SERVICE BULLETIN

Number: SB0403

Subject: Z60 Lift Mount Recall

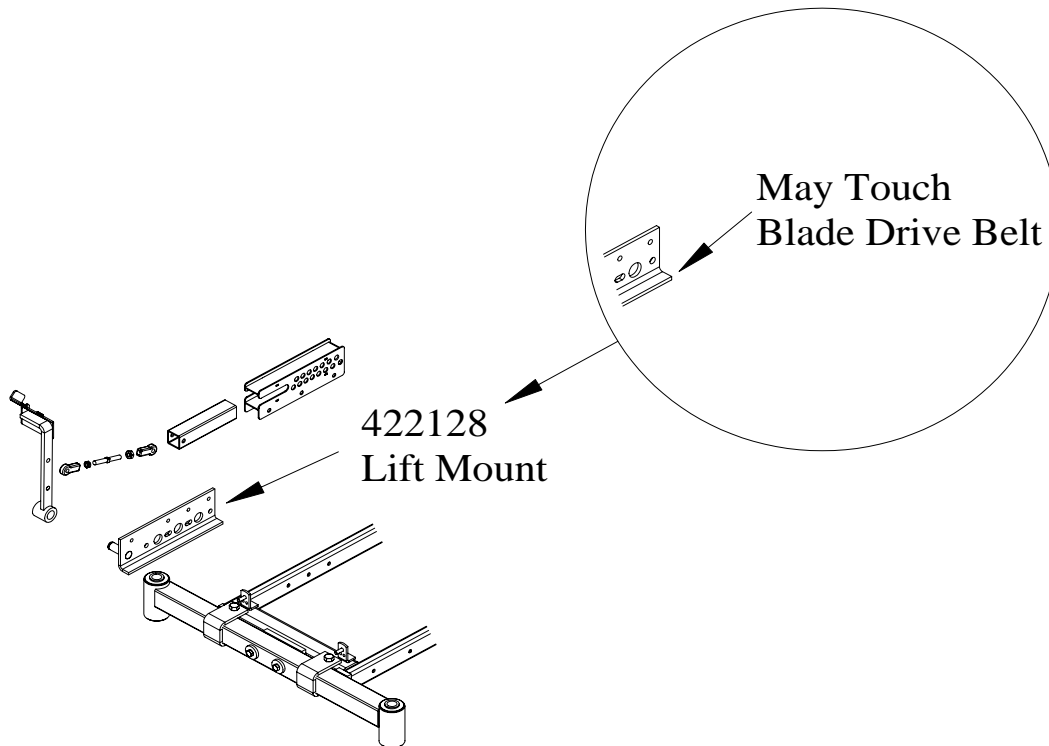
Details: The Lift Mount for the 60K25Z, part # 422128, is being **RECALLED**. It has been discovered that on some Z60 machines, the corner of the Lift Mount may actually touch the blade drive belt when the deck height position is in the 3-1/2" and above positions. This in turn may cause premature wear or breakage on the blade drive belt.

Please replace this component (as shown in diagram below) via the standard warranty procedure:

- 1 Order replacement Lift Mount, part # 422128 from your distributor.
- 2 Replace existing lift mount with modified replacement Lift Mount, 422128. Encore will pay 1/2 hour labor for this replacement.
- 3 Ship original lift mount back to your distributor so that it may be returned to Encore. Please include necessary warranty information in box with part being sent back.
- 4 Submit Warranty Claim Form via USPS or online at www.encoreequipment.com.
